# United States Patent and Trademark Office

APPLICATION NO.	FI	ILING DATE	FIRST NAMED INVENTOR	ATTORNEY DOCKET NO.	CONFIRMATION NO.	
10/702,372	11/05/2003		Ming-Dou Ker	JC-7897-DIV	8473	
23900	7590	02/02/2006		EXAMINER		
J C PATE	•		STARK, JARRETT J			
4 VENTURE, SUITE 250 IRVINE, CA 92618				ART UNIT	PAPER NUMBER	
, -				2022

## **DETAILED ACTION**

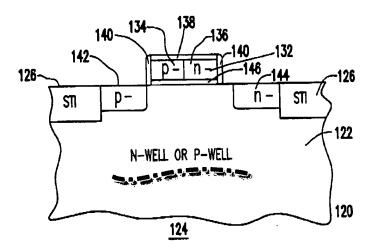
Regarding claims 39 & 46, the applicant argues that <u>Voldman et al.</u> does not disclose the well. The examiner points out to the applicant that Figs. 2,4, & 7 and the front page of US Patent 6,015,993 all show the well. <u>Voldman et al.</u> Col. 4, lines 20-25 states:

"a lateral unidirectional bipolar type insulated gate transistor is formed in an implanted well 152 in a surface semiconductor layer 154."
